Draft Presentation Materials for July 15, 2010, Meeting with NRC to Discuss a Request for Additional Information Regarding Boron Dilution, Precipitation, and Long Term Cooling

U.S. EPR Design Certification Review RAI 403 Proposed Response

AREVA NP Inc. and the NRC
July 15, 2010

RAI 403, Question 15.06.05-61 Proposed Response

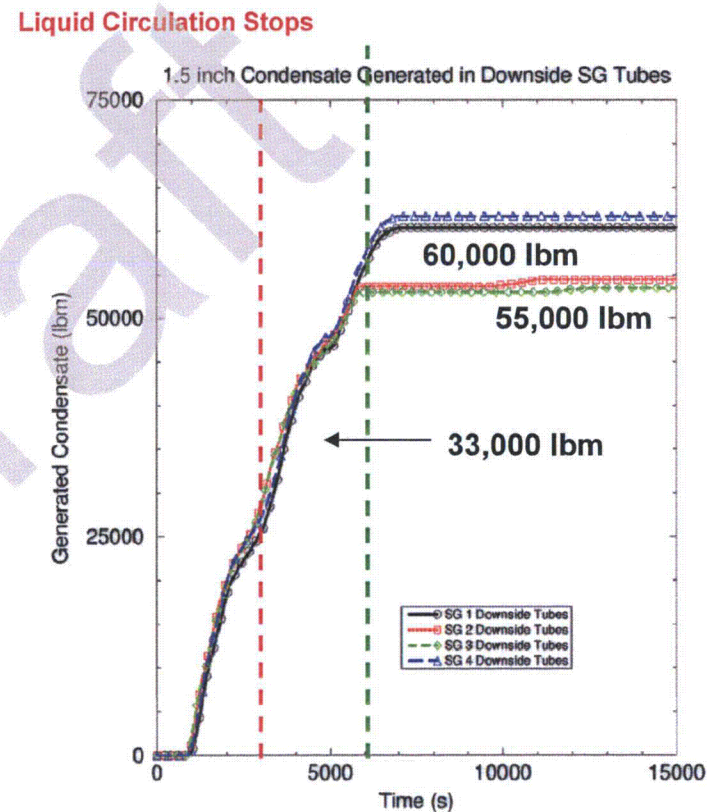
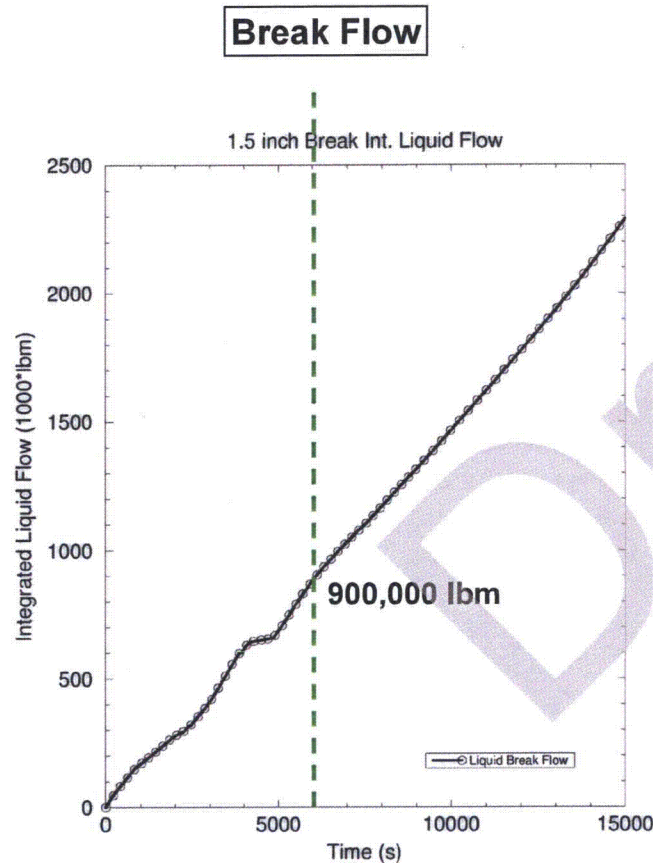
- ▷ In response to Question 15.06.05-29, the applicant did not provide an assessment of the amount of condensate generated by reflux condensation as was requested. Instead, predictions for the liquid content in control areas defined as “steam generator (SG) outlet plenum,” “loop crossover pipe,” and “cold leg” were presented. Provide a calculation of the amount of condensate generated by reflux condensation accounting for conditions with emergency feed water (EFW) supply present for two or more SGs.

- ▷ The staff requests a mass balance accounting for the steam generated in the core by decay heat, steam lost out the break, steam condensed in the SGs, condensate in countercurrent flow returned to the reactor vessel hot leg, condensate collected on the SG, loop crossover pipe, and cold leg, condensate lost out the break, and condensate transported to the vessel downcomer.

- ▷ The staff requests a description of situations involving stratified conditions in the cold leg and downcomer regions.

Upside Tubes

Liquid Circulation Restarts

Downside Tubes

Liquid Circulation Restarts

▷ S-RELAP5 Entrainment Model

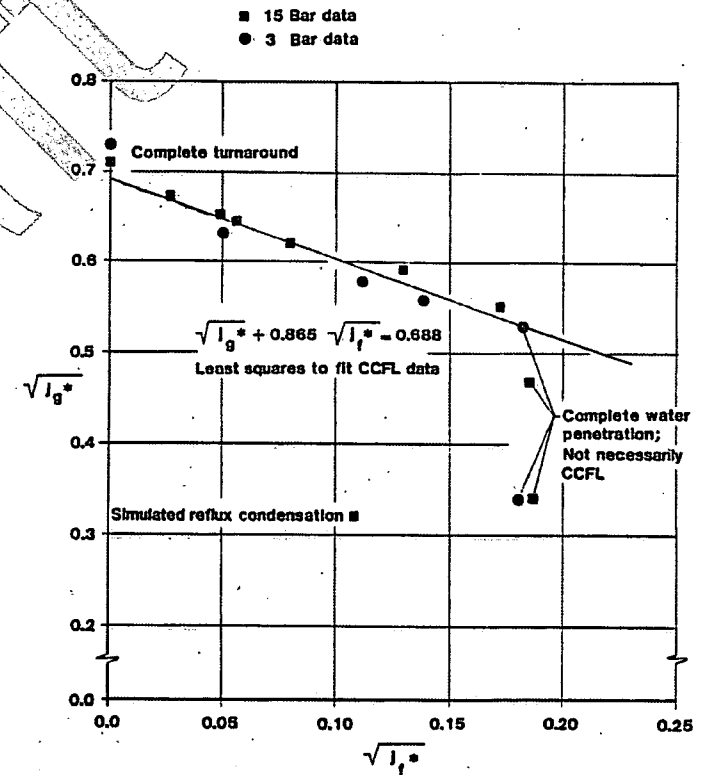
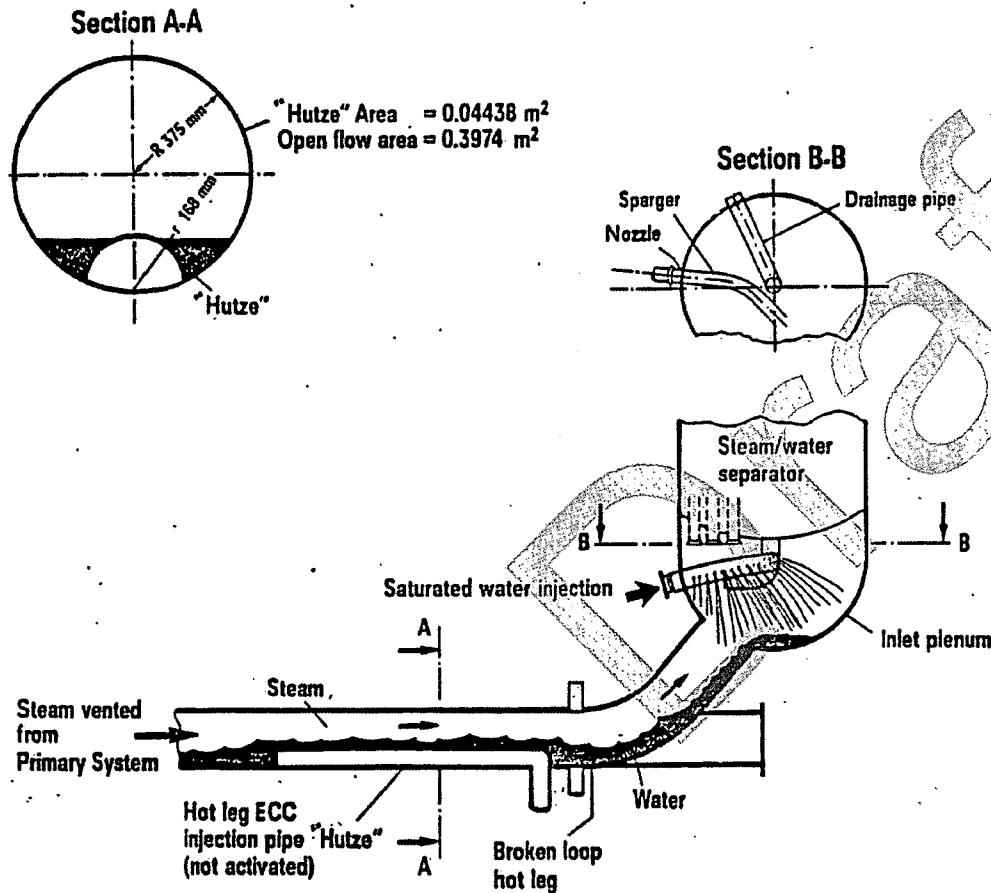
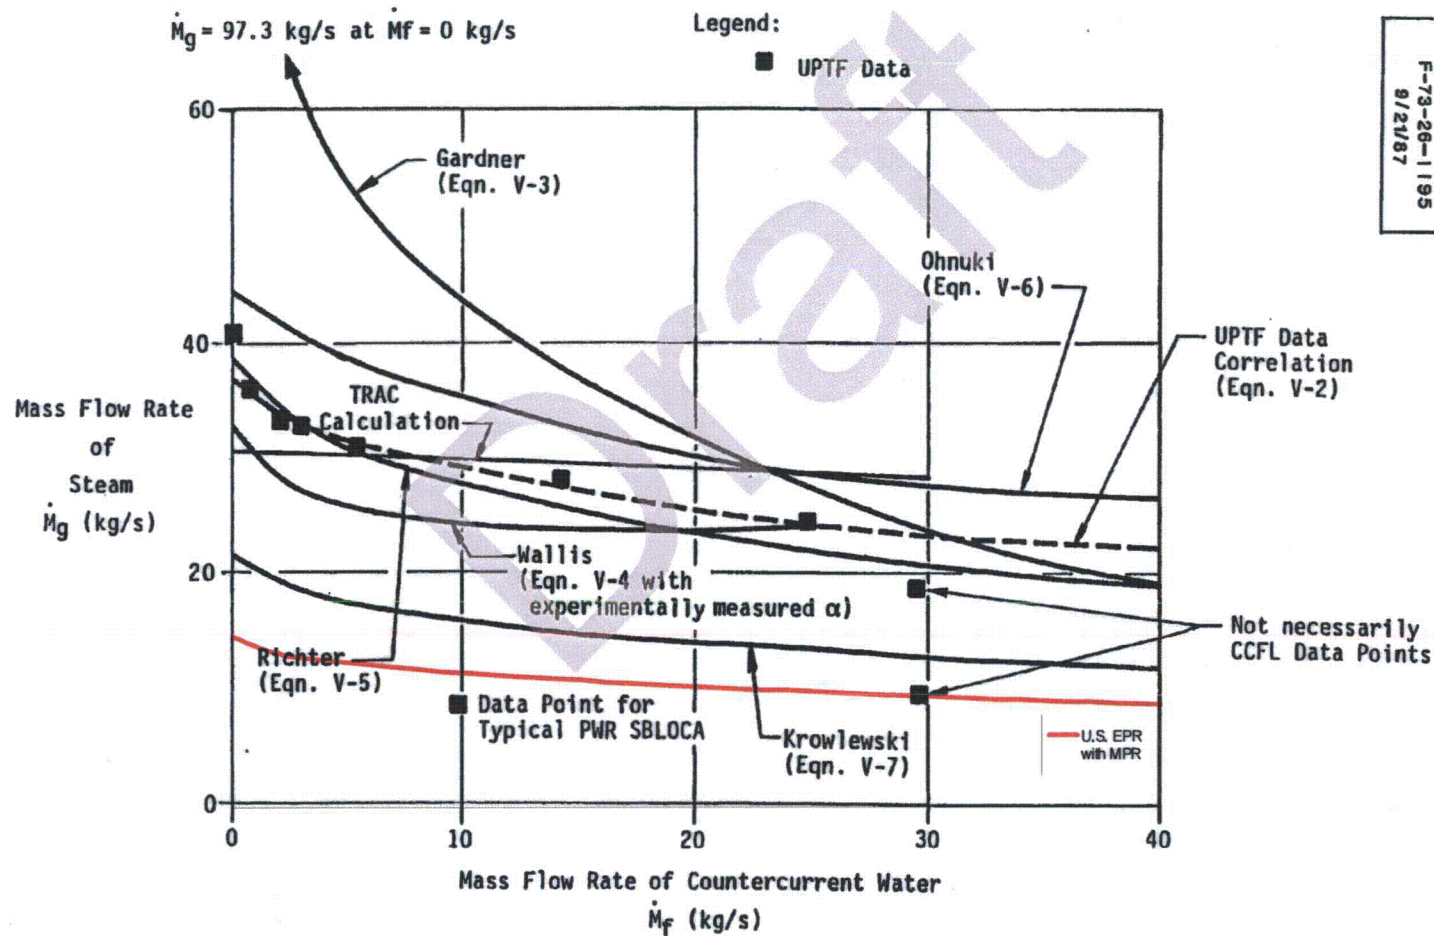
- ▷ Since the hot side injection at 60 minutes will be entrained into the hot legs and inlet plenum, there is no assurance that sufficient water will enter the core in a timely manner to prevent boron precipitation. As water enters the steam generators slug flow can increase the loop resistance and upper plenum pressure which can limit the growth of the mixing volume and lower the reflood rate. Stating the water will eventually drain back into the core is inappropriate. Provide the model and results to demonstrate that hot side injection is not entrained into the loops causing a potential inadequate core cooling conditions. Describe the entrainment model and show the results demonstrating that hot leg injection is effective in preventing boron precipitation.

- ▷ Describe standard entrainment models used in S-RELAP5 analyses
- ▷ Describe MPR correlation
 - ◇ Test applicability
 - ◇ Comparison to other correlations
- ▷ Perform S-RELAP5 RLBLOCA analyses with an increase in the decay heat to simulate ANS 1973 x 1.2
- ▷ Perform S-RELAP5 analyses using the MPR correlation
 - ◇ Compare results
- ▷ Summarize hot leg injection presentation from March audit
 - ◇ Induced mixing flows
 - ◇ Test data showing penetration
 - ◇ CFD showing penetration

► ACHILLES PRELIMINARY NODAL MODEL FOR S-RELAP5

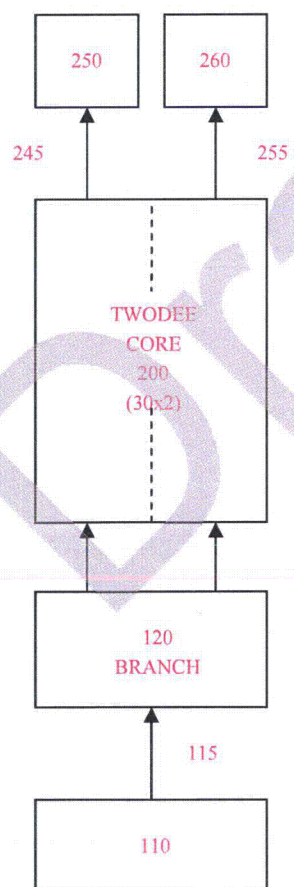
- ▶ The level swell validations described for S-RELAP5 were pertinent to large break loss of coolant accident (LBLOCA) short term conditions during the periods of significant entrainment. No comparisons of the models to long term level swell when entrainment subsides were provided. Show validation of the level swell model against low pressure level swell data such as those, for example but not limited to, the Achilles and Thetis low pressure level swell tests. For clarification, it is understood that an under predicted void fraction value in the upper plenum compensated will significantly increase the liquid mass within the mixing volume.

- ◆ Develop S-RELAP5 model of the ACHILLES Test A1L066
- ◆ Compute collapsed liquid and mixture levels for comparison to reported results.
- ◆ Test features:
 - 69-rod electrically heated rod bundle with stepped sine axial power
 - Low pressure (1.2 bar),
 - Constant power (80 kW)
 - Water levels are measured during boil-off
- ◆ Used standard LOCA analysis S-RELAP5 code options.

RAI 403, Question 15.06.05-68

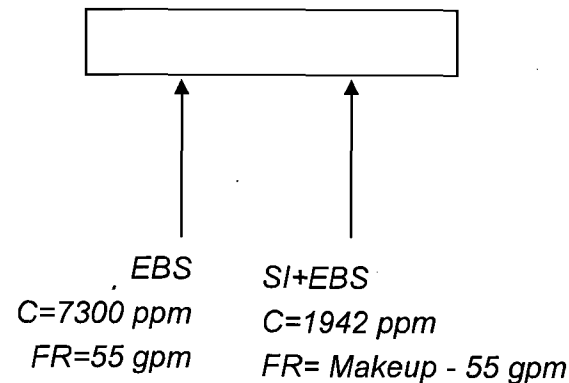
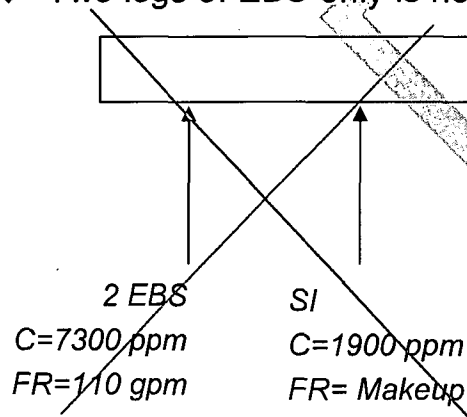
- ▶ The average concentration of all of the boric acid sources was calculated to be 1,929 ppm based on their volumetric contents and boric acid concentrations. Since liquid from the various sources is injected into the reactor coolant system (RCS) at individual flow rates and concentrations over different periods of time, setting the concentration of the fluid entering the core equal to the volume-averaged value is not justified.
- ▶ If the EBS is injecting at its maximum rate, this concentration at this flow rate can be conservatively postulated to enter the core region along with the remainder needed to supply the core boil-off rate at the in-containment refueling water storage tank (IRWST) concentration. The excess spills to containment. Show the timing to boric acid precipitation under these specific flow conditions using all other limiting conditions suggested/questioned above.

- ▶ Mixed Volume Concentration Used: 1929 ppm
- ▶ Flow Rate Weighted Concentrations
 - ◇ 0 EBS + 2 (MHSI+LHSI): 1900 ppm
 - ◇ 1 EBS + 2 (MHSI+LHSI): 1949 ppm
 - ◇ 2 (EBS + MHSI + LHSI): 1998 ppm
- ▶ Maximum EBS, Minimum SI
 - ◇ Diagrams provided for configurations with possible SF/PM scenarios
 - ◇ Two legs of EBS only is not a possible configuration

AXIAL POWER SHAPES

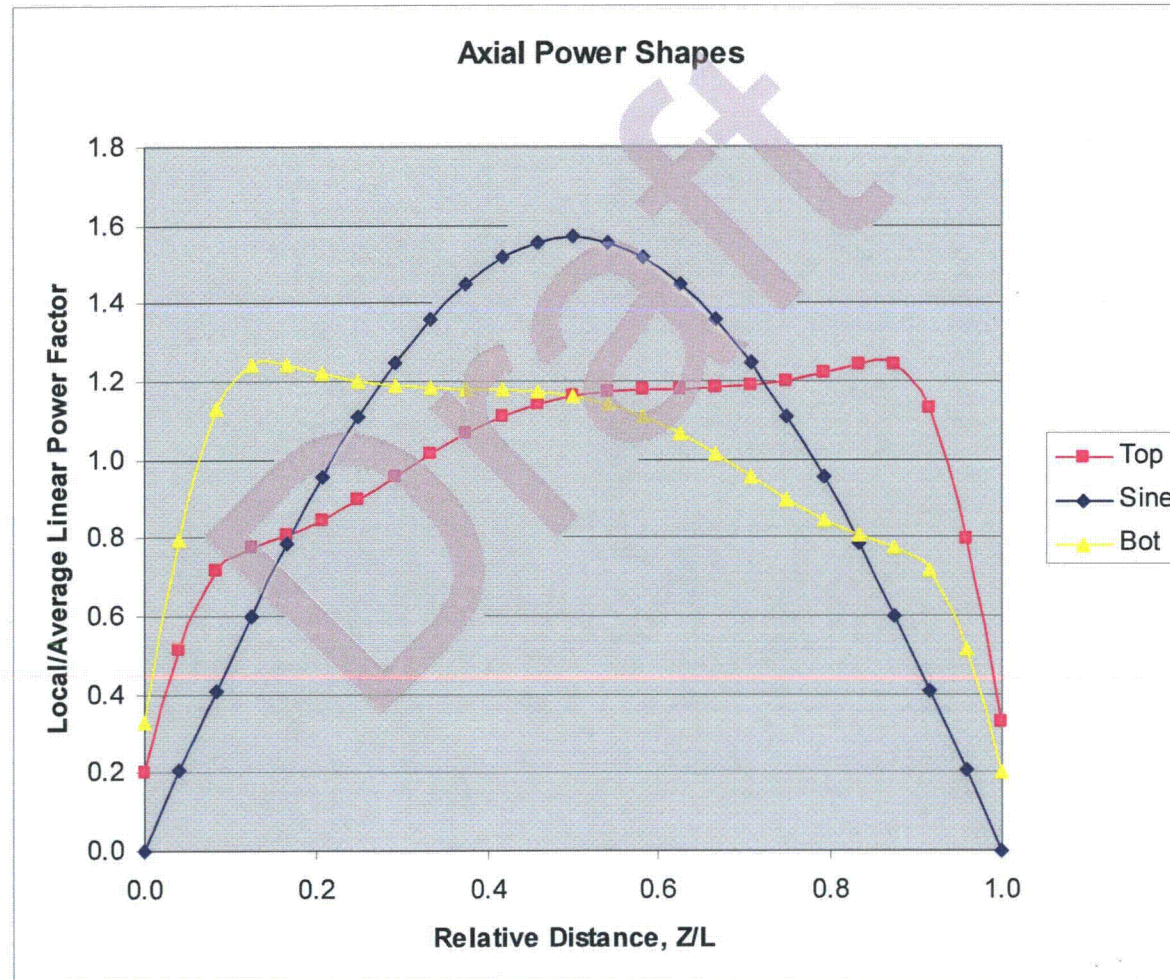
- ◆ The axial power distribution is taken as uniform. The staff believes that a top skewed power distribution will result in a lower two-phase mixture level due to less void swell. Quantitatively show the sensitivity of the two-phase mixture level to a top skewed axial power distribution under most limiting physically realizable top peak profile.

- ◆ Perform the analysis with bottom, sine, top and uniform axial power shapes
- ◆ Show that top peaked produces lowest swell but impact is small.
- ◆ Core is always covered by a two-phase mixture regardless of axial power shape
